**Re: Rapiscan AIT System Radiation Survey Reporting**

## Rapiscan Secure 1000

**R-0646-1 Addendum  
(Documentation Errors)**

Product Name	Secure 1000SP (Single Pose)
Serial Number	S51039012
Radiation Emission Measurement	Radiation Survey Dated: 12/07/2010
RSO Initials

**3. Inspection Zone Boundary Radiation Measurement: Survey Table. 3**

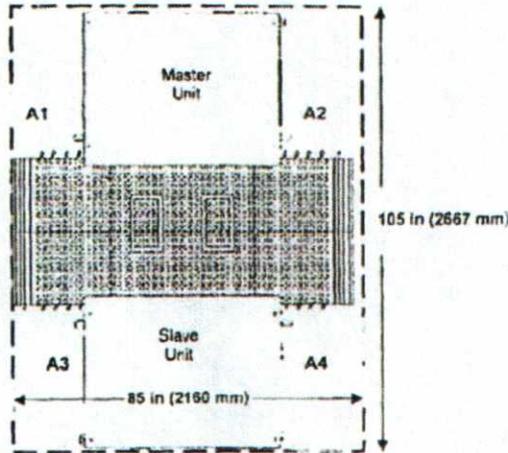
1. Survey meter's actual calibration date was recorded as a calibration due date.
2. TABLE 3: Incorrect presentation of data in Column 3 for Measured Exposure. Indicated value is .1 uRem. The correct value should be 1 uRem.
3. TABLE 3: Incorrect presentation of data in Column 6 for Dose Equivalent. Indicated value is .18 uRem. The correct value should be 1.8 uRem.

The service technician should attend refresher training.

The corrected data indicates this system was operating within expected parameters. No re-survey is required for this system.
